ISP Methodology Consultation Paper

The Major Energy Users is pleased to respond to the AEMO request for a submission to its consultation paper related to its ISP methodology.

Figure 3 Cost and capacity of REZ network expansion options

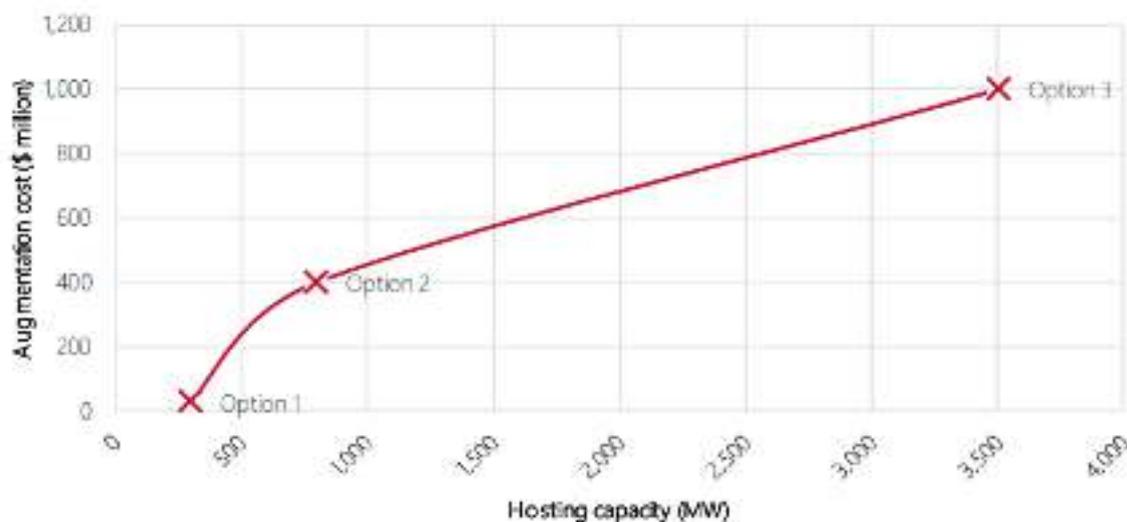
The MEU notes that AEMO plans to develop the costs for each REZ based on the design characteristics of each REZ rather than costing based on a formula using MW capacity as the basis for the costs. The observation provided by the MEU at the Issues paper stage assumed that AEMO would use figure 3 to generate REZ costings.

The MEU pointed out that the chart is wrong on the basis that historically costs increase to the power 0.7 with an increase in size⁴ leading to the conclusion that interpolation will give a different answer than following a linear path.

As AEMO apparently intends to assess the cost of each REZ based on an actual concept design for the ISP, the MEU concern is unnecessary.
